# TRAPPER MINING INC.

*Re: Trapper Mining Inc., Permit No. C-1981-010*

## **Technical Revision, TR-130, Response to Adequacy Review No. 1**

Figure 1. H-Seam overburden removal area. Red denotes cut to attain PR-09 PMT on east highwall of L-Pit.

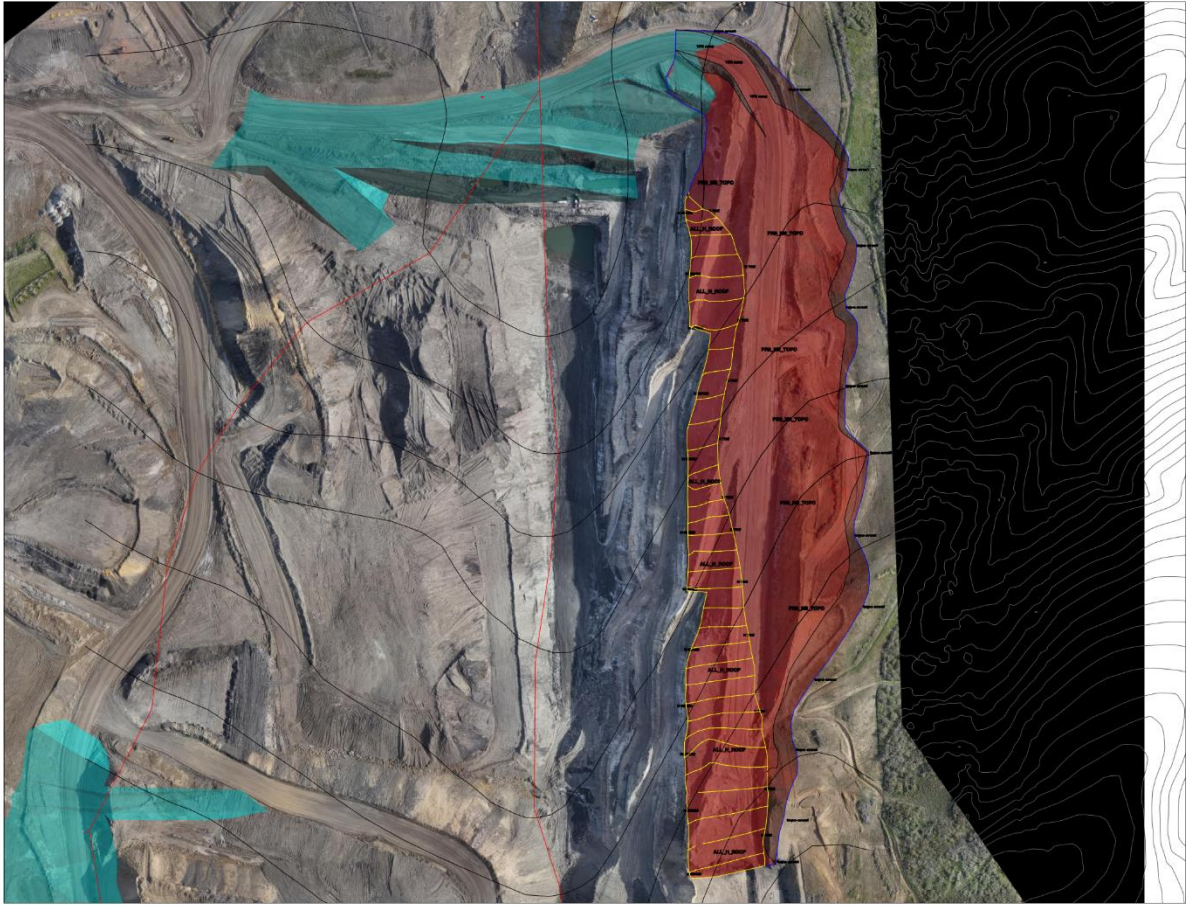
1. *Please indicate on a map or explain in text where the H seam overburden will be placed or stored for placement.*

2. *Please demonstrate that the reclamation costs for H seam overburden removal and stripping have been accounted for in previous permitting actions.*

5. *Has the opening of H seam been calculated in the reclamation bond to date?*

The attached image demonstrates areas of the L-Pit highwall crest that may be excavated for the H-Seam coal and attain the PMT as approved in PR-09. Red shaded areas are cut and the blue areas demonstrate fill from this material.

**Trapper Response to Comment 1:** H-Seam overburden removed from the highwall area of the current L-Pit cut 18 will be placed in the spoil benches west of the L-Pit cut in the same manner as the current spoils awaiting regrade. The material will need to be removed from the highwall crest to attain the currently permitted PMT for L-Pit.

**Trapper Response to Comment 2:** As demonstrated in the attached Figure 1 and discussed verbally on May 17<sup>th</sup> the material proposed to be removed on the highwall of L-Pit will need to be removed to attain the currently approved PMT. These costs would be calculated in the PR-09 worst case bonding scenario as regrade costs for L-Pit. No new stripping is currently proposed in the L-Pit area with this proposed overburden removal.

**Trapper Response to Comment 5:** As noted above, no new topsoil stripping will take place to mine the H Seam coal in the L-Pit high highwall. As the attached pit image demonstrates this material would cut from the highwall crest in order to attain the currently approved PMT for the area.
